UNITED STATES PATENT AND TRADEMARK OFFICE

APPLICATION NO.	FILING DATE	FIRST NAMED INVENTOR	ATTORNEY DOCKET NO.	CONFIRMATION NO.
10/811,695	03/29/2004	Mark James Kline	9595	1368
27752 7590 11/19/2007 THE PROCTER & GAMBLE COMPANY INTELLECTUAL PROPERTY DIVISION - WEST BLDG. WINTON HILL BUSINESS CENTER - BOX 412 6250 CENTER HILL AVENUE CINCINNATI, OH 45224			EXAMINER BOGART, MICHAEL G	
			ART UNIT 3761	PAPER NUMBER
			MAIL DATE 11/19/2007	DELIVERY MODE PAPER

Office Action Summary	Application No. 10/811,695	Applicant(s) KLINE ET AL.	
	Examiner Michael G. Bogart	Art Unit 3761

DETAILED ACTION

Fig. 2

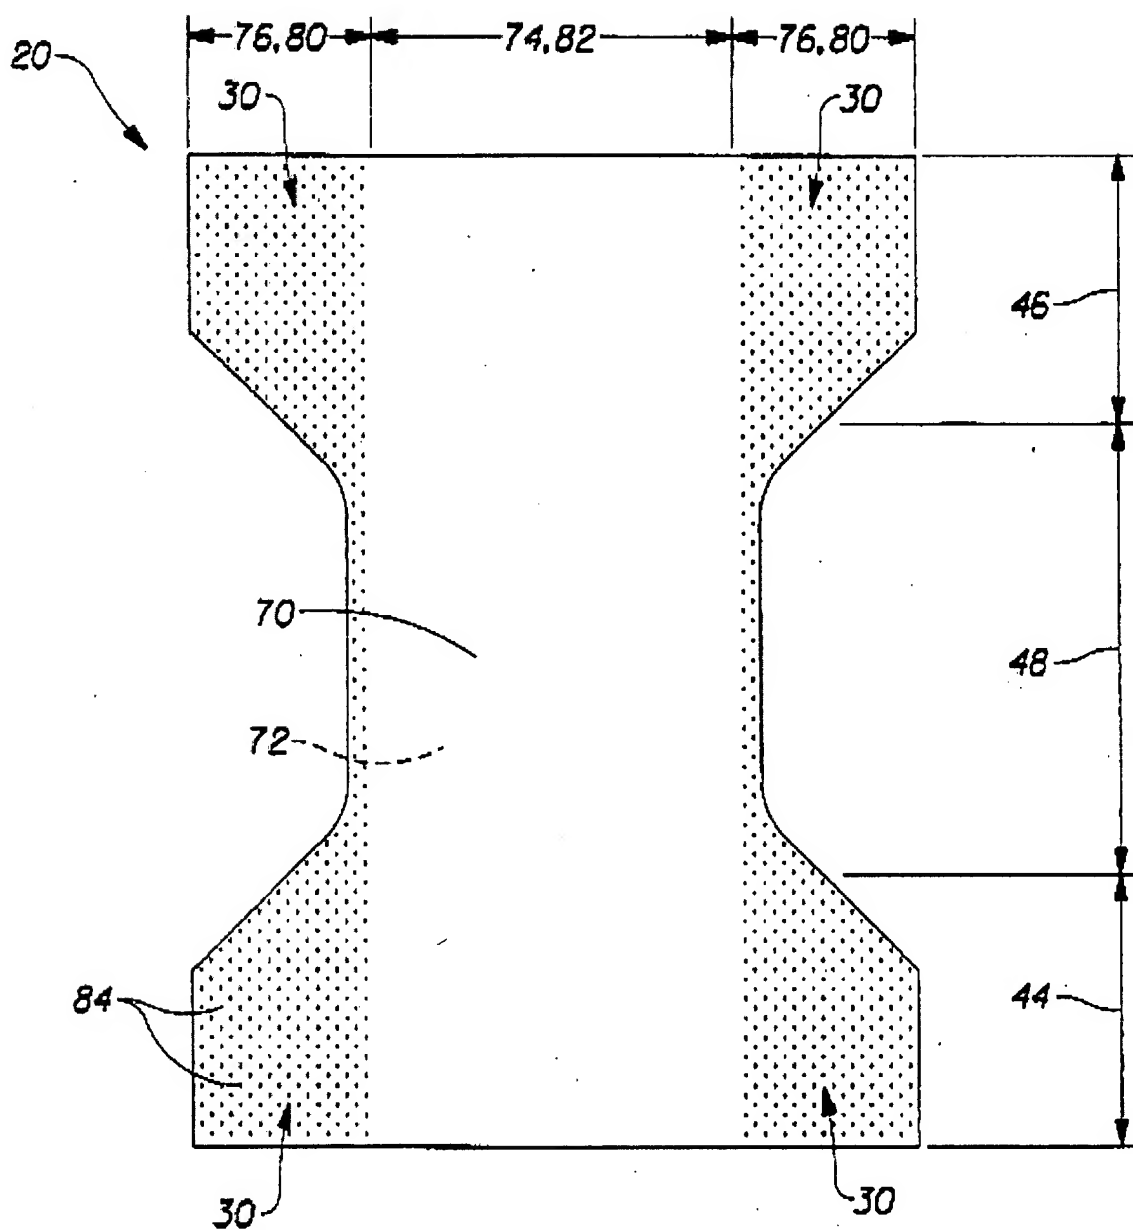
a second stretch region (34, 44) having lateral stretch; wherein said first stretch region is capable of co-elongating with said second stretch region (see figure 2, *infra*). The limitation concerning the co-stretchability of the elastic elements is functional. An apparatus claim must be structurally distinguishable over the prior art. MPEP § 2114.

Drobin teaches that the apertures may be formed by cutting holes out of a film without forming cones, such that the apertures will have a caliper the same as the film thickness, which necessarily means that some material will be removed from the film leaving it with a decreased density and basis weight (col. 9, lines 28-30). The result is that the unperforated portion (82) of the backsheet (26) has a greater basis weight and density than the perforated portions (80). First backsheet zone (46) has a much larger area that is perforated than second backsheet zone.

Applicants assert that Dobrin does not teach a second backsheet zone longitudinally outboard from the first backsheet zone with a second basis weight that is less than the first basis weight. This argument is not persuasive because the first zone is now considered to be element (48) which contains a much smaller perforated area than second zone (46). Thus the first zone (48) would have a higher basis weight than the second (46).
